# AMPEX

SERVICE BULLETIN

DATE: 20 March 1953  
MODEL: 300  
BULLETIN NO: 2  
PAGE NO: 1

FIG. 8

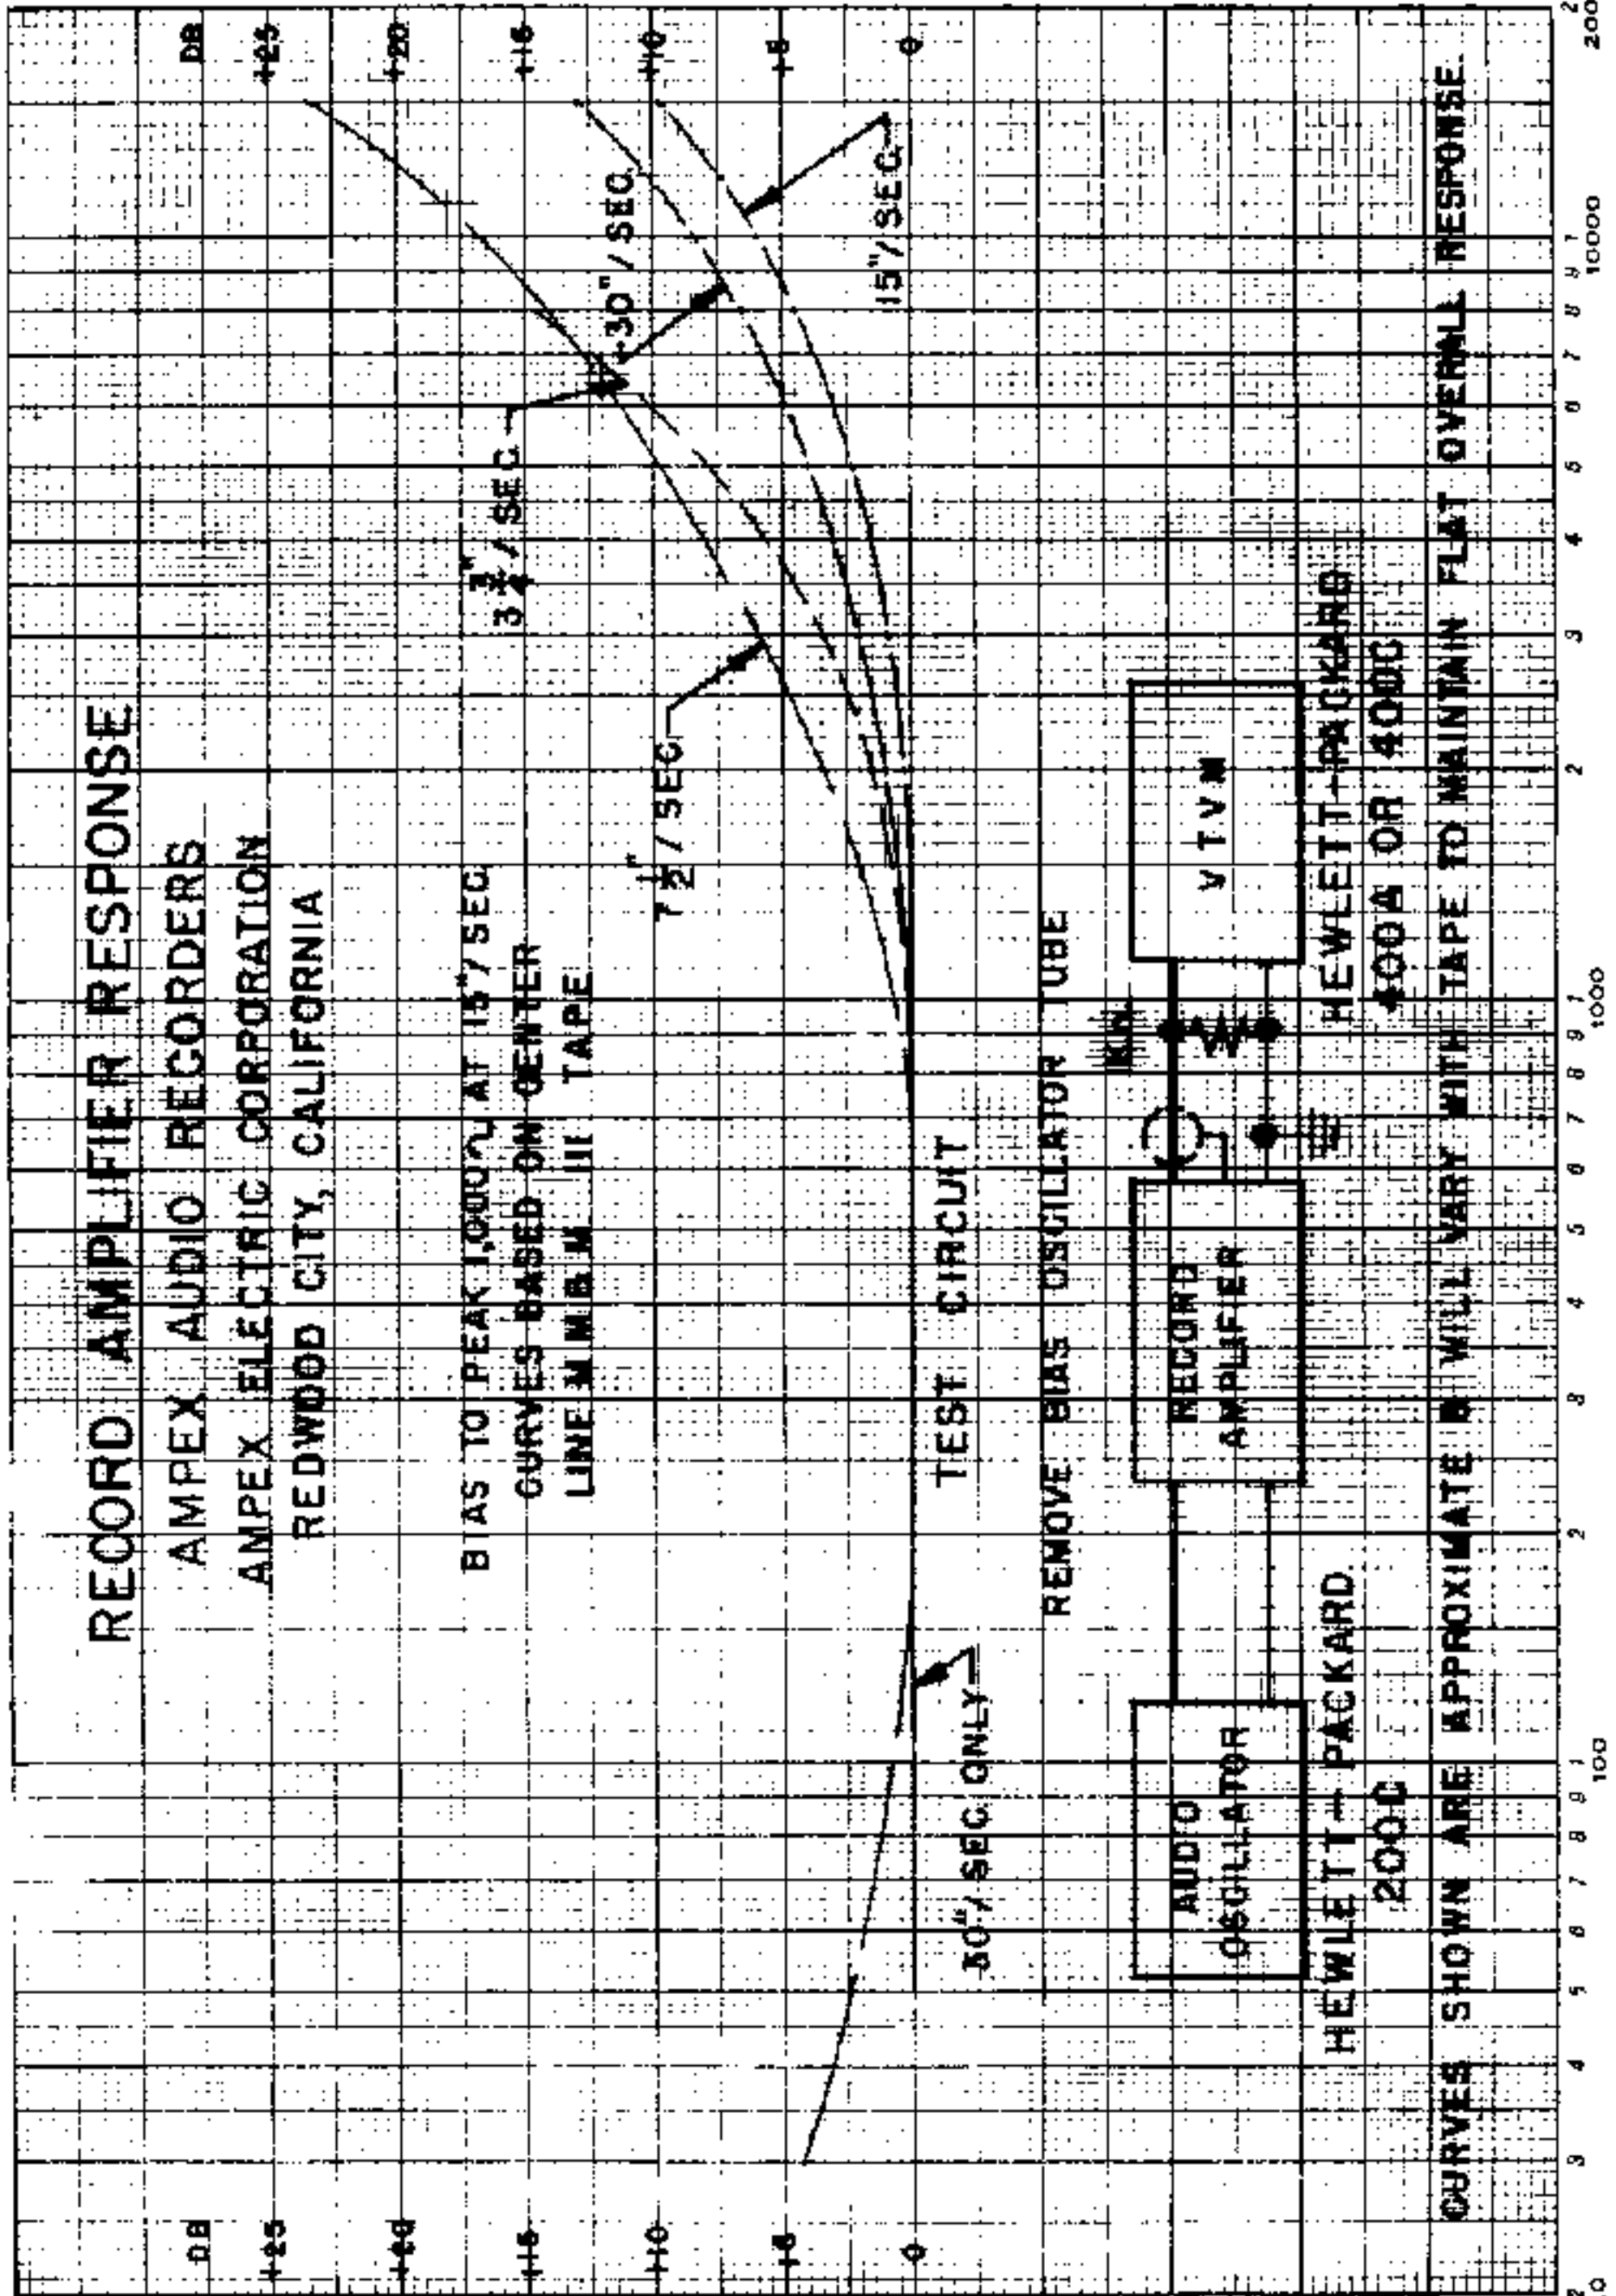
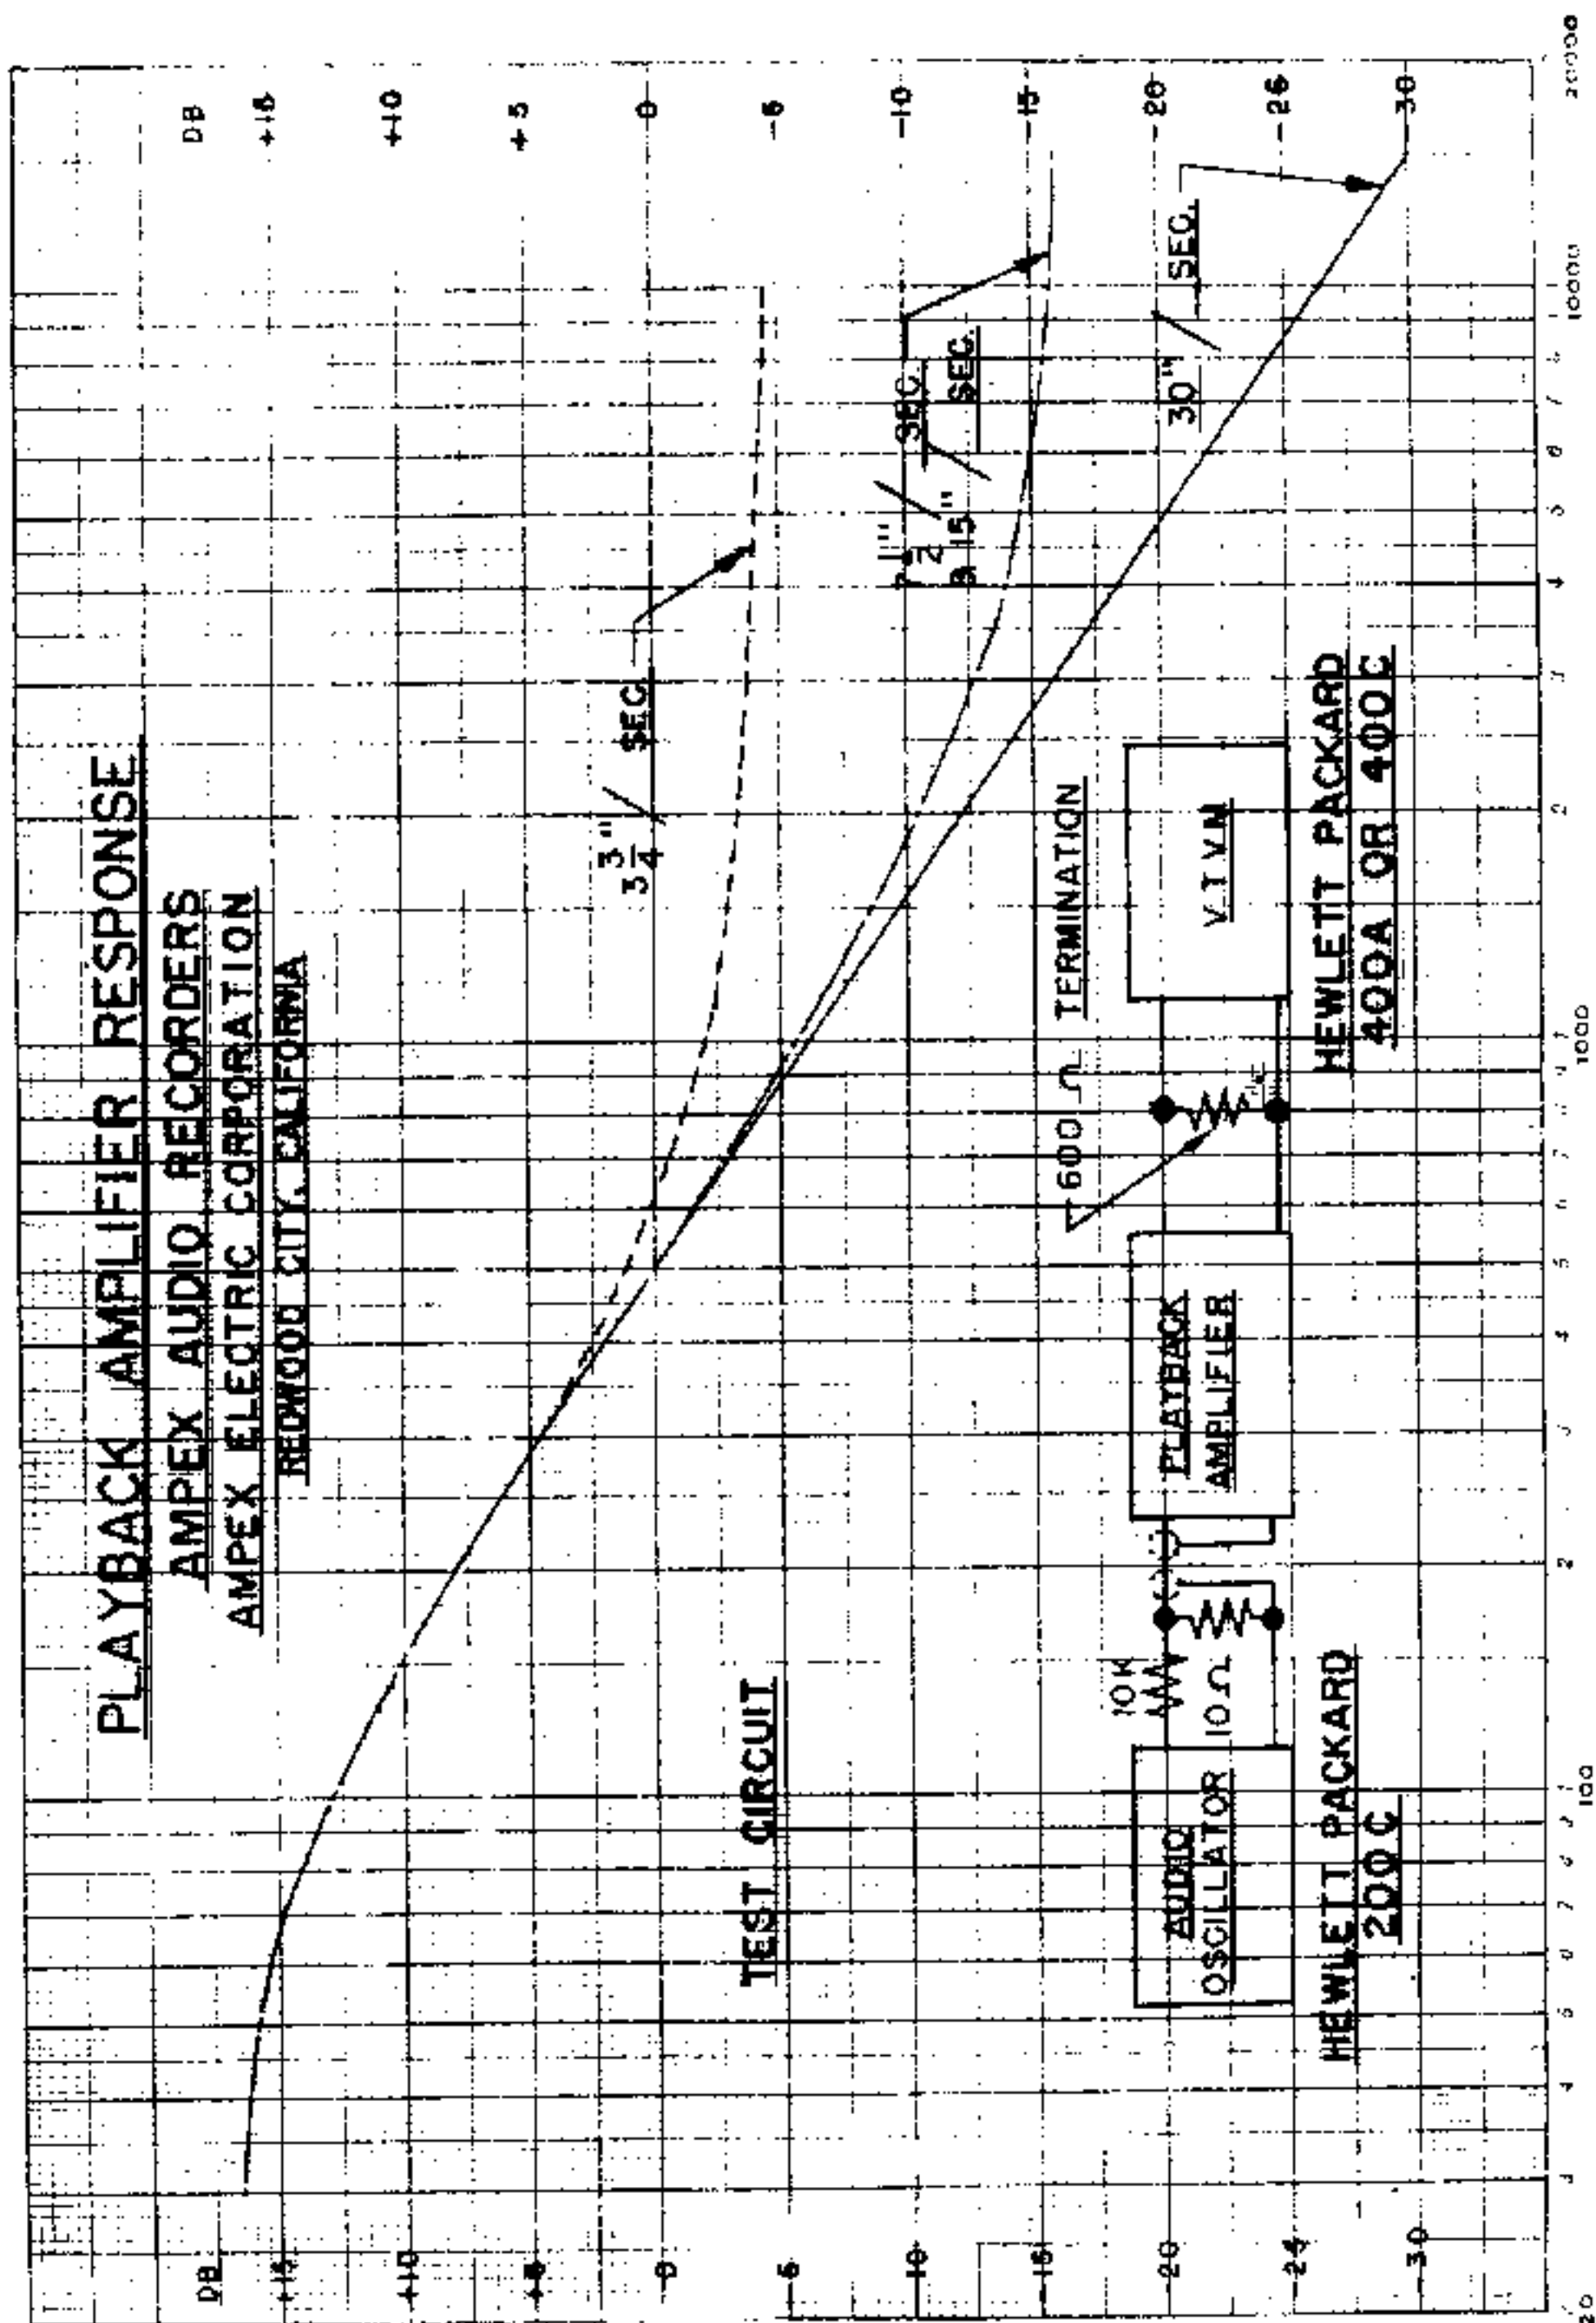
F. If the earlier Model 300 recorders are to be converted to take full advantage of the improved performance possible with present tapes and also to have extended range  $7\frac{1}{2}$ " response, the following changes in the record and playback electronics will have to be made depending upon the serial number category of the recorder:

1. The playback equalization circuitry in the grid stage of V203 must be changed to that circuitry shown on the attached playback amplifier diagram. Discard the old R207, 470,000 ohm resistor. The new R207 is a 5,000 ohm potentiometer, Ampex Catalog #RE-273. Discard the old C206, a .006 condenser and substitute the new C206, a .036 condenser, Ampex Catalog #CO-111. Rewire these parts in accordance with the playback amplifier schematic attached.

(Refer to record amplifier diagram for the following steps)
2. In the record amplifier, R106 must be changed to a 39,000 ohm  $\pm 5\%$  1 watt resistor. This resistor is Catalog #RE-44.

3. Condenser C123, a 100 mfd 50 volt condenser, Catalog #CO-63, must be added as shown on diagram.
4. Relay K102, Catalog #RL-2, should be added as shown. On J104P jumper terminals 1 and 9. Lead from R122 to terminal 2 on J105 should be reconnected to terminal 10 on J104P. Disconnect lead to terminal 10 on J104P from C109 (for this change compare new schematic with schematic furnished with original instruction book.)

5. Wire lead from bottom side of L101 to one outside rotor contact of J102. Connect to stator contacts of this section of the relay the new C109, Catalog #CO-10, and C110, Catalog #CO-21, condensers as shown.

6. Connect rotor of other outside relay section to the point between C102 and R105. Add the new trimmers C125 and C126, both bearing Catalog #CO-92, to stator contacts of this section as shown on attached diagram.

- Fig. 6 - 9-3-52 - Record Amplifier & Power Supply
- Fig. 8 - 1-2-51 - Playback Amplifier
- Fig. 16- 9-5-52 - Record Amplifier Response Curves
- Fig. 17- 9-5-52 - Playback Amplifier Response Curves
- Service Bulletin #19 - Parts List - 9-26-52
- Specification Section 1 Page 1 - 2-29-52
- Specifications Section 1 Page 2 - 2-29-52

### USING 7" RTMA REELS

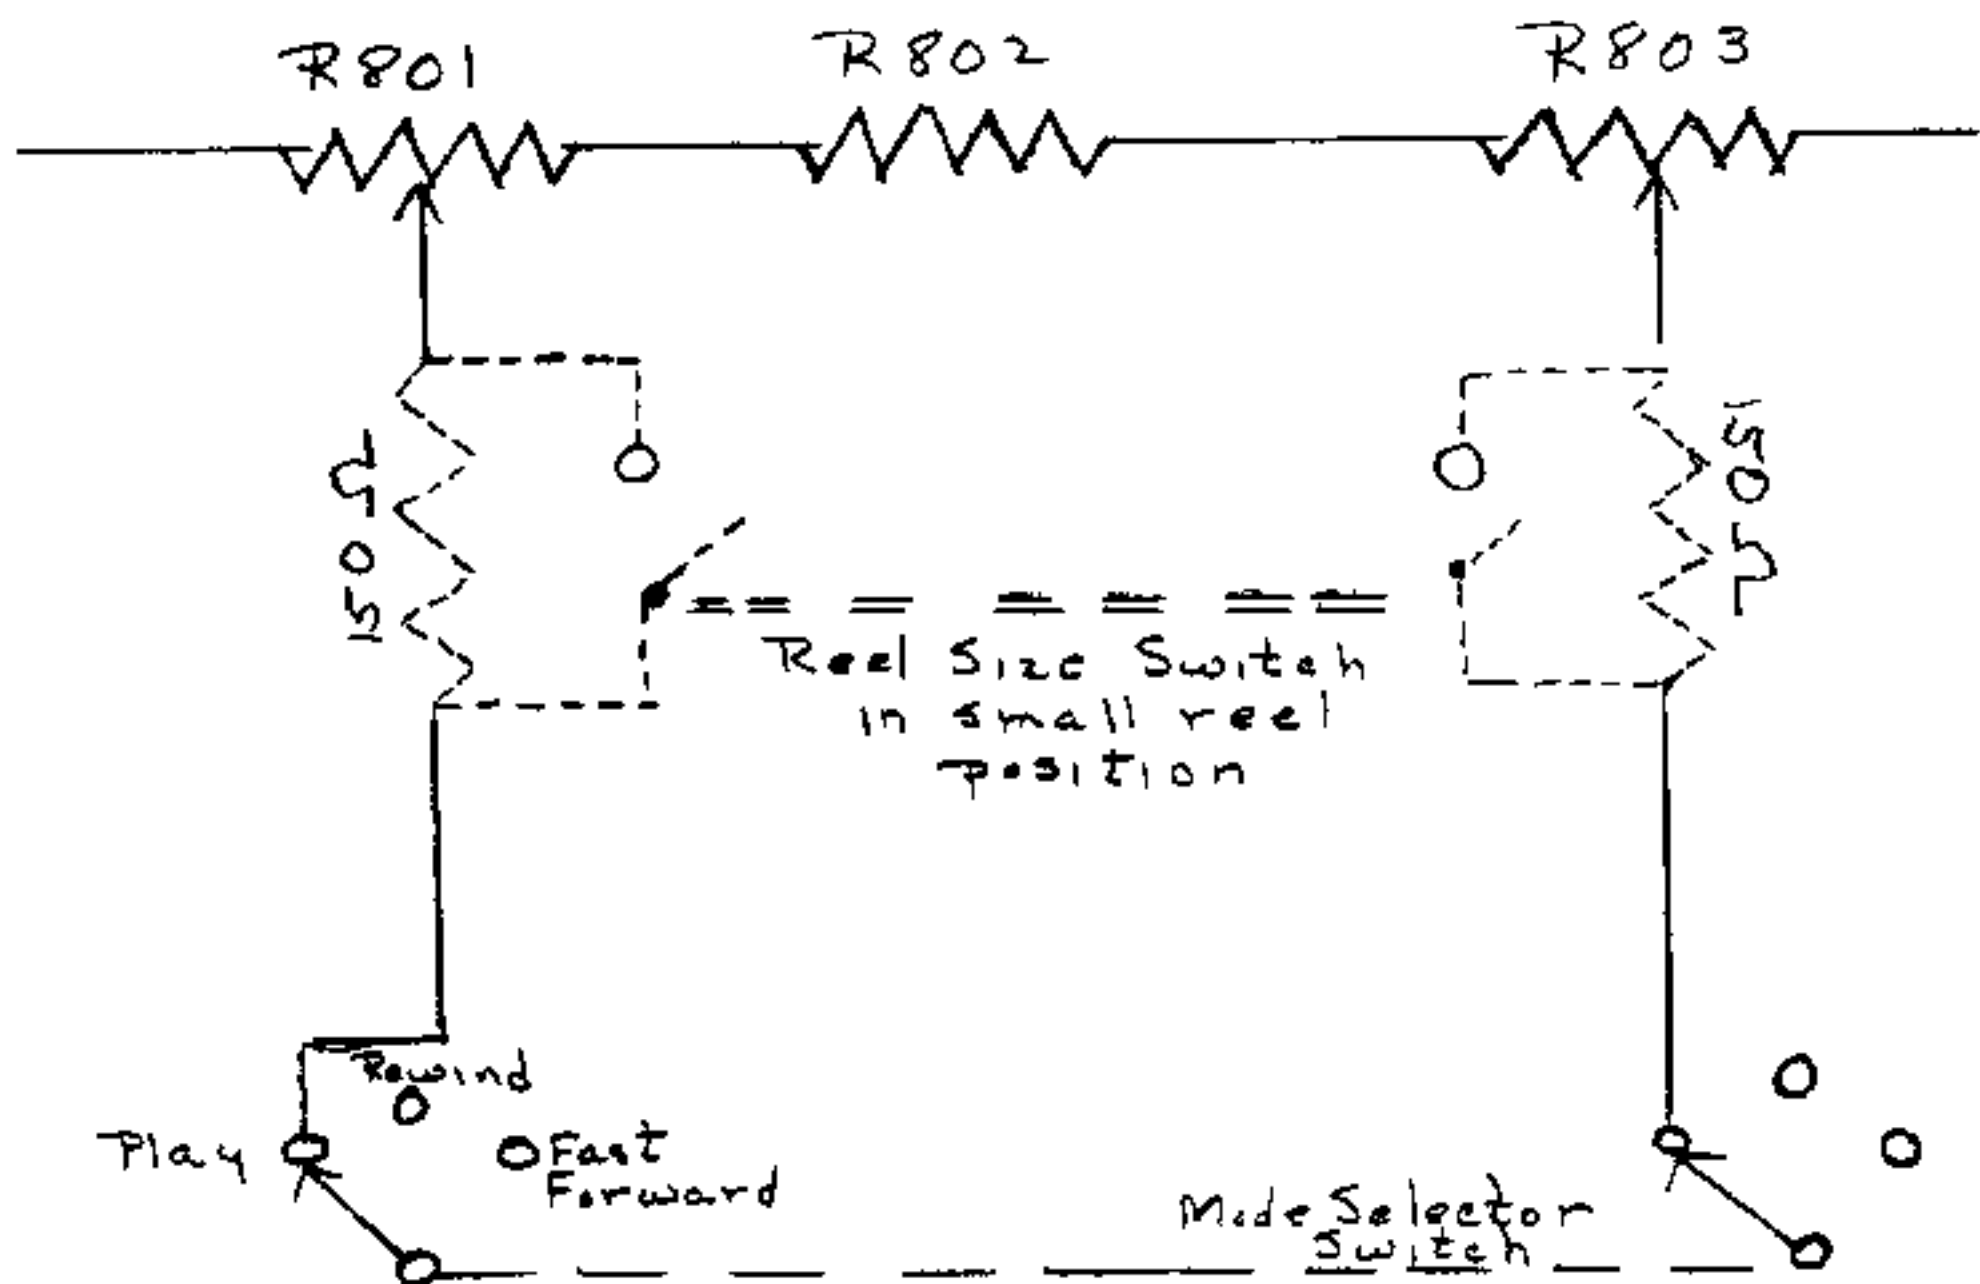
If it is desired to use the new editing knob assemblies, catalog #1917, with a Model 300 recorder which does not have the holes drilled in the turntable, the attached drawing will serve as a template diagram for drilling these holes.

When drilling these holes care should be taken that metal filings do not fall into the end-bell of the turntable motor. This can be accomplished by wrapping a cloth around the end-bell on the under side of the top plate while drilling.
